Technical Memorandum

Project Number: 2018-66

Re: 151 Chapel Street – Transportation Addendum #4 (Version 3)

SITE PLAN

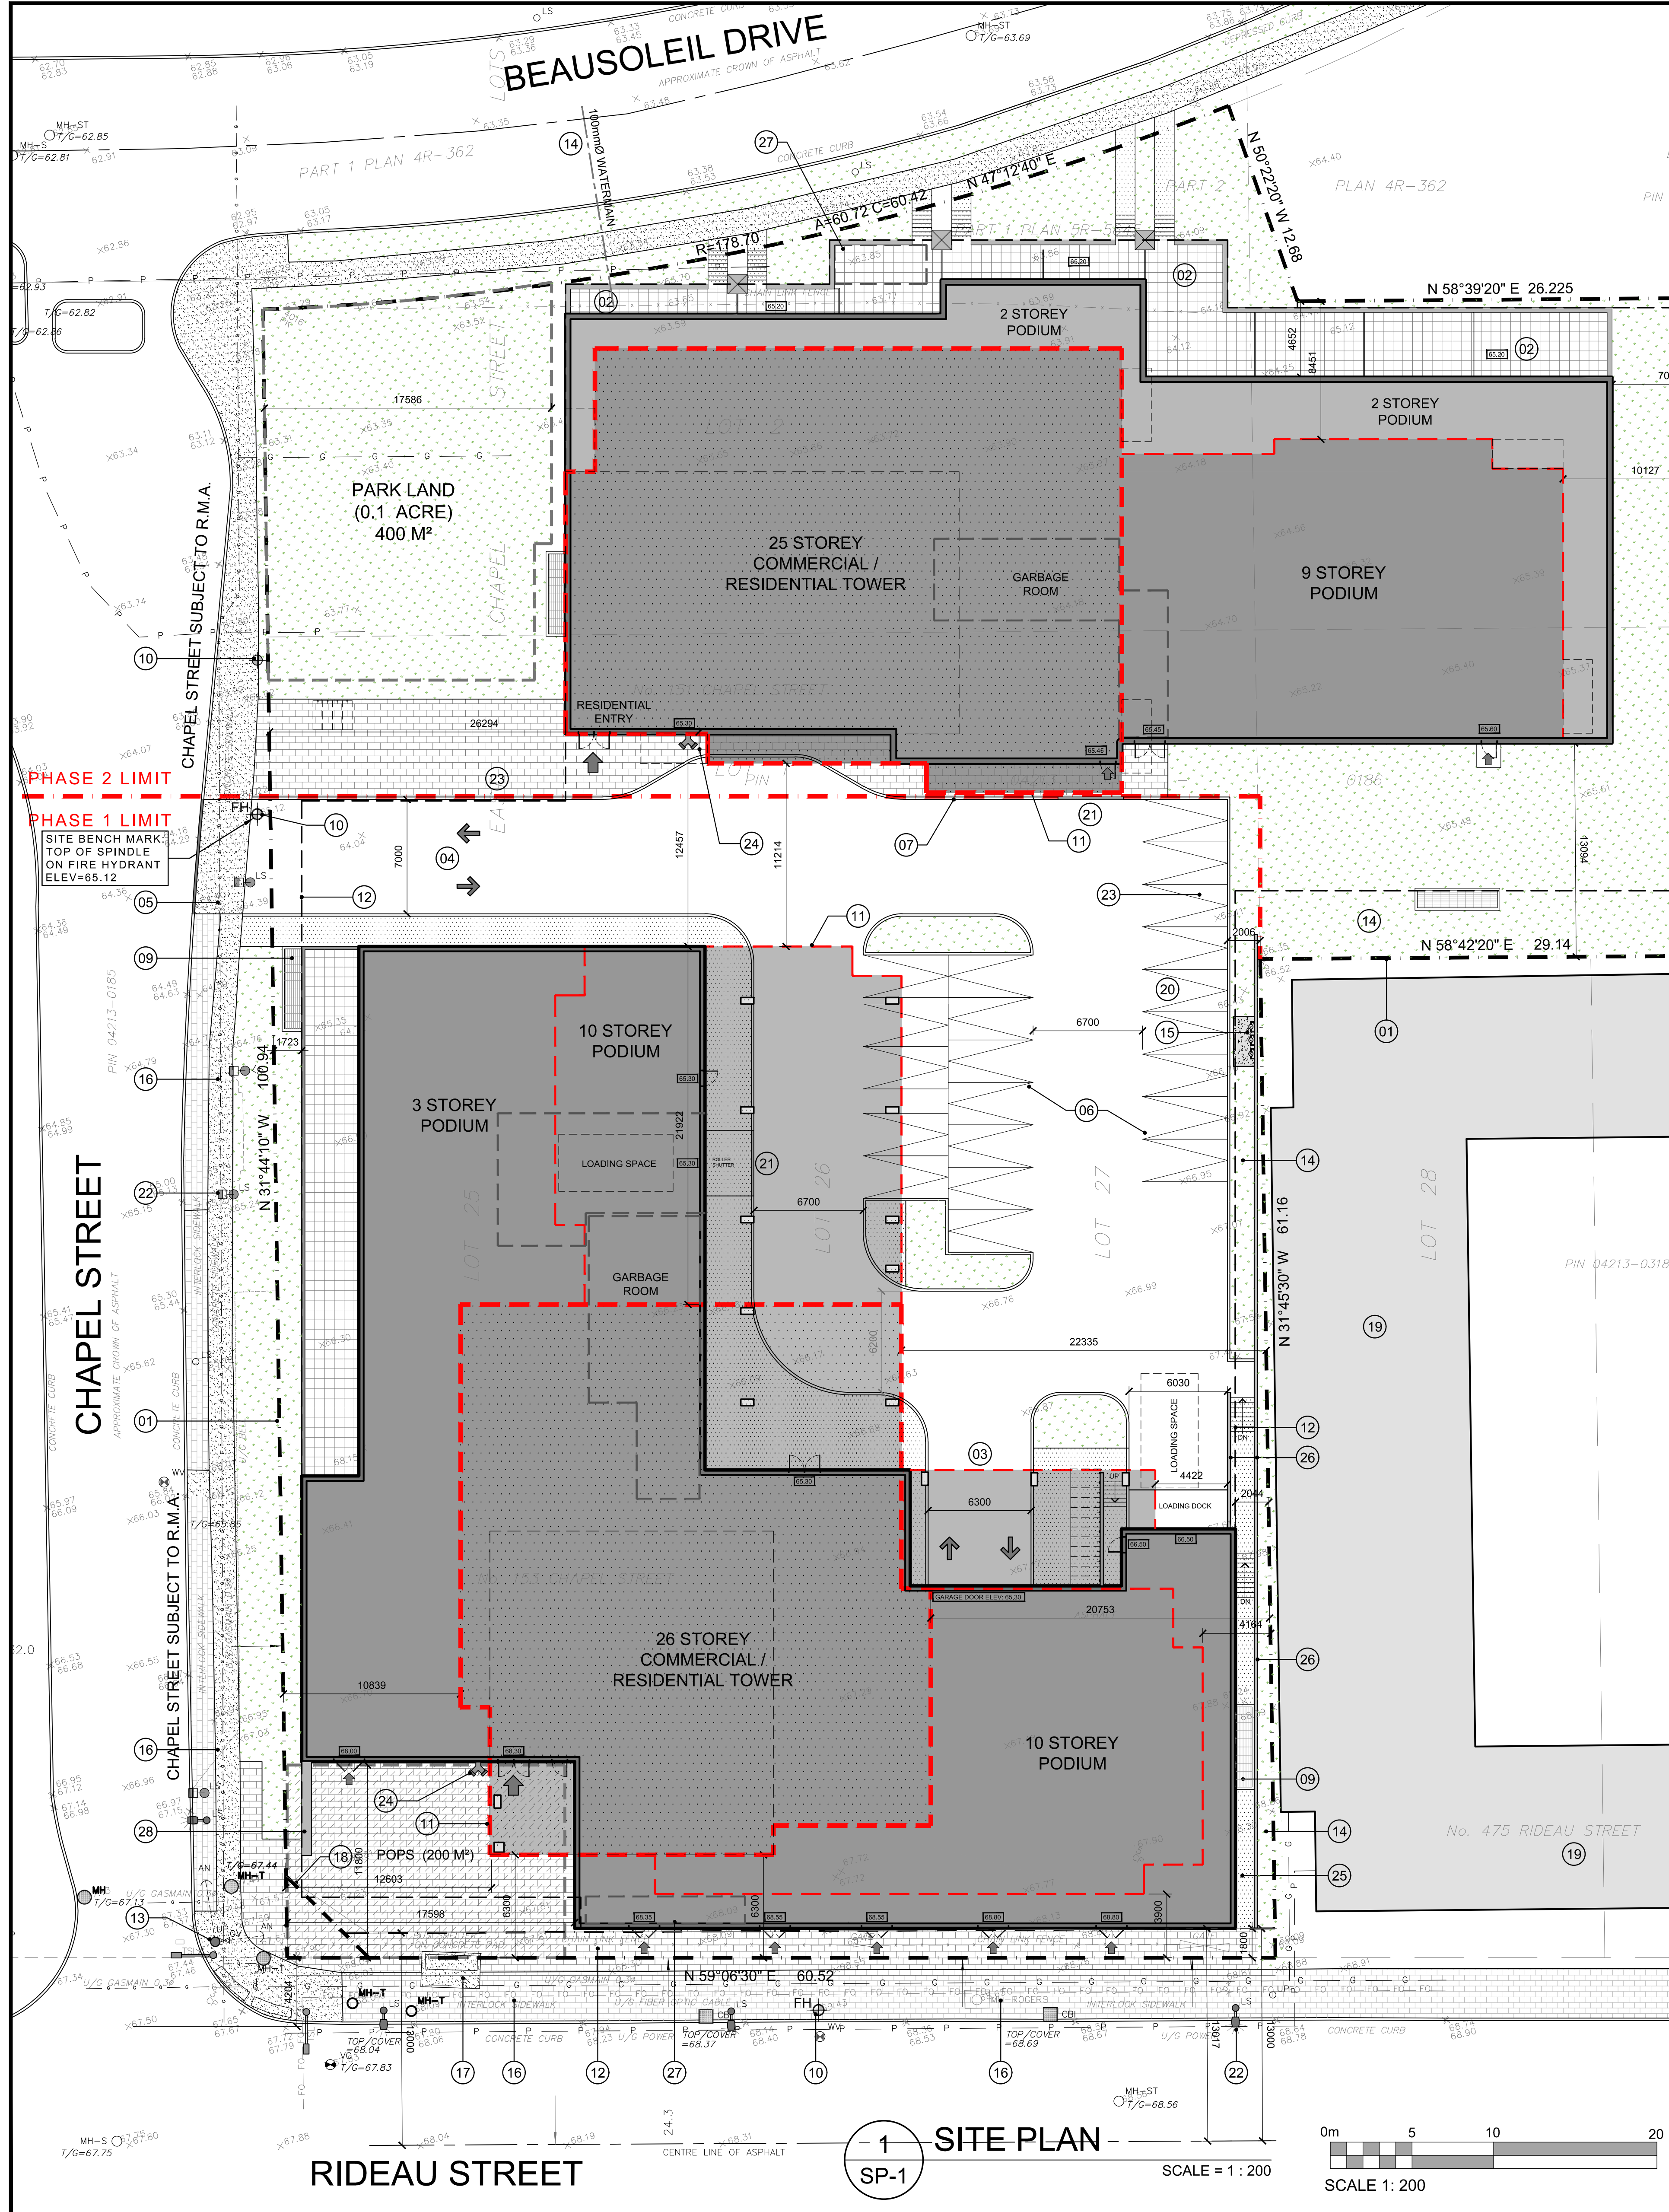
Figure 1 illustrates the new Site Plan for the 151 Chapel redevelopment. The project will be constructed in two phases. Between the two phases, the total number of residential units is 633, total commercial space is 819 s.m., and a total of 477 vehicle parking and 366 bike parking stalls will be supplied.

41. Clearly indicate the 13 m road widening from the existing center line on Rideau Street.	Noted on Site Plan drawings.
42. Complete the TDM checklists as indicated in the 2017 TIA Guidelines. Look for opportunities to reduce vehicle needs by encouraging alternative modes. In particular, review in detail access for cyclists. Cyclists require a safe and manageable access to their bicycles. Consider storage facilities at grade level or elevators that can accommodate bicycles to underground parking. Advise if car sharing spaces are anticipated in parking garage.	Section 6 of the CTS (2014) addresses TDM measures.

Figure 2: 2021 Total Future Traffic

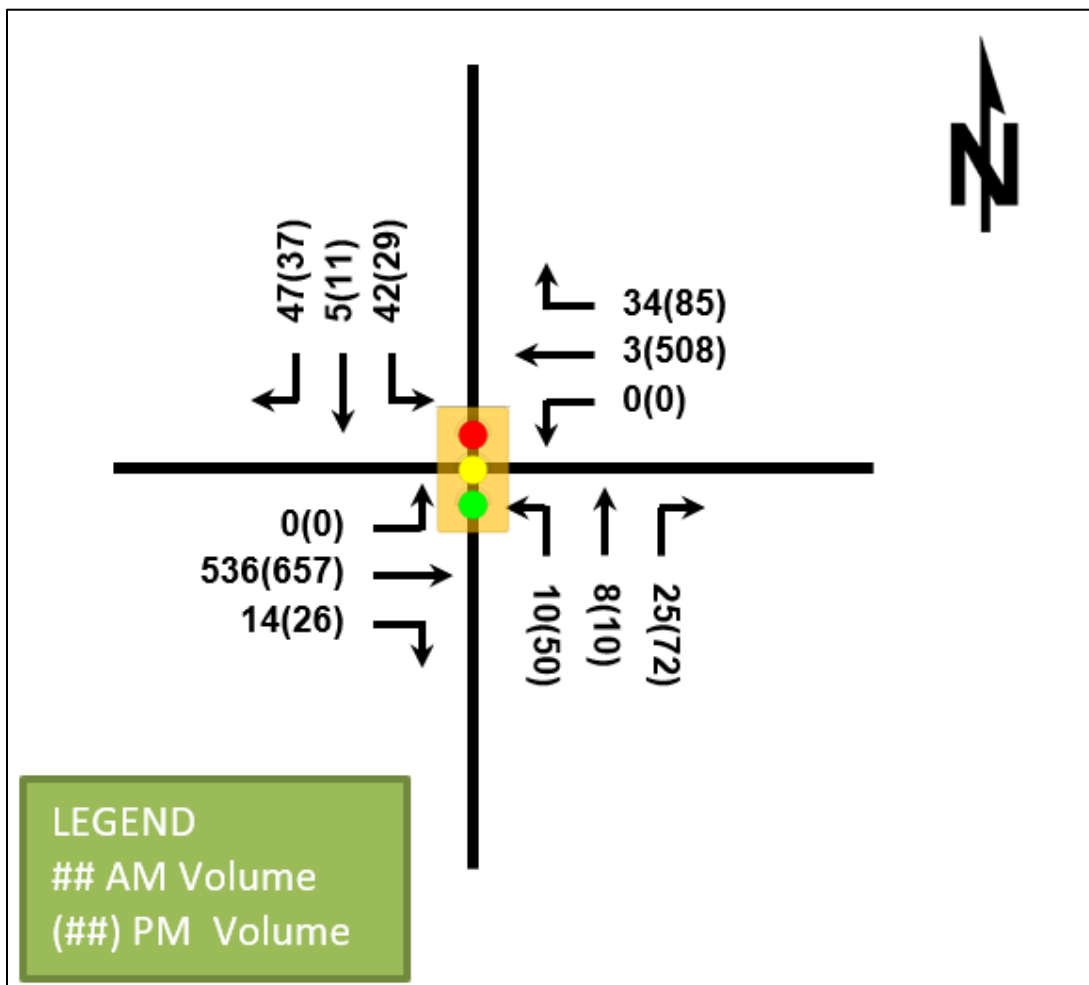
37. The report contains no information on the timing of the phases. Background volumes and total volumes should be updated accordingly. Provide the background volumes, site generated volumes and total projected volumes at buildout and 5 year post development	This memo has shown that the change in land use statistics would result in a net reduction in the traffic volumes,

at the intersections of Rideau/Chapel and Rideau/Cobourg in a figure format.	therefore no additional analysis is required.
38. The report indicates 114 additional vehicles will use the Rideau/Chapel southbound approach. Provide details of the impact of these additional vehicles. A review of the neighbourhood impacts is required as a result of the changes to the site accesses and the increase in vehicles at this intersection. Review in detail the turning restrictions at the Rideau/Chapel intersection and the expected change in traffic patterns with only one access to the site.	As noted above, the additional vehicles amount to a 3 to 5% change in traffic volumes through the subject intersection.

43. Provide the final peak hour volumes at the intersection of Rideau Street and Chapel Street at final build out.	Refer to Figure 2 above.
44. There is existing underground traffic infrastructure that might be impacted by proposed construction. (NE quadrant). Due to the proposed changes in the existing roadway geometry, the City of Ottawa Traffic Operations Unit is required to assess the impact and complete a traffic signal plant relocation design if needed. Detailed design drawings for road modifications should include a geometric detail design drawings (dwg digital format NAD83 coordinates) including base	There are no longer any offsite modifications proposed therefore this comment is no longer applicable.

As requested through the comments from the City of Ottawa, Figure 2 illustrates the total future traffic volumes at the intersection of Rideau and Chapel. This combines the 2021 future background volumes from the CTS (2014) with the updated trip generation and assignment.
